Intel® Celeron™ Processor Specification Update

Release Date: December 1998

Order Number: 243748-009

Figure 20. Side View Space Requirements for the Boxed Processor

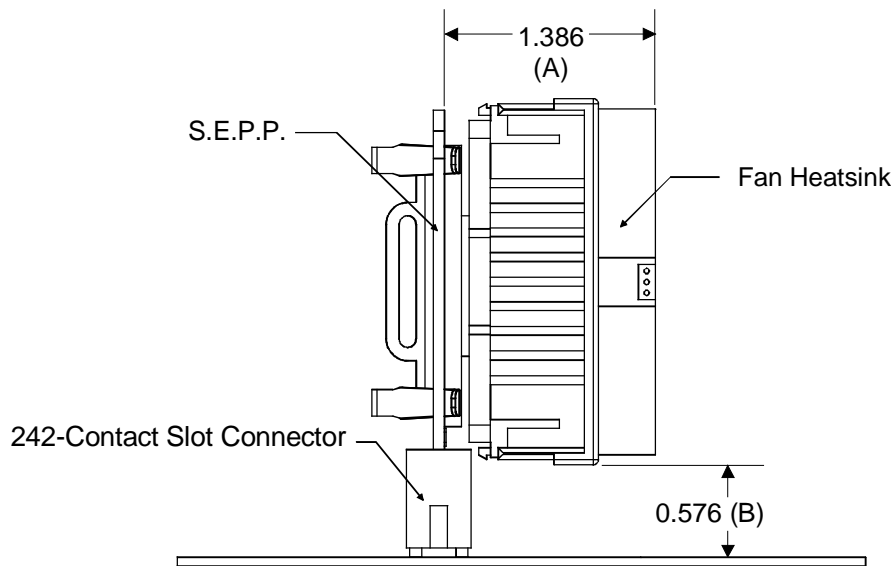
Figures 20, 21, and 22, and Table 34 of Section 6.2 of the *Intel Celeron Processor at 266 MHz, 300 MHz, 300A MHz, and 333 MHz Datasheet* show incorrect fan heat sink dimensions for the boxed Intel Celeron processor. The correct figures and table are shown below.

The maximum depth of the fan heat sink to the processor substrate should be 1.386", not 1.291" max. The minimum height clearance above the baseboard should be 0.576", not 0.485". The fan shroud height should be 2.02" and 4.74", respectively, not 2.19" max. and 4.90" max. Figure 22 should show reference "G" for the minimum airflow keepout zone from the inlet of the fan heat sink, and reference "F" for the minimum airflow keepout zone from the ends of the fan heat sink.
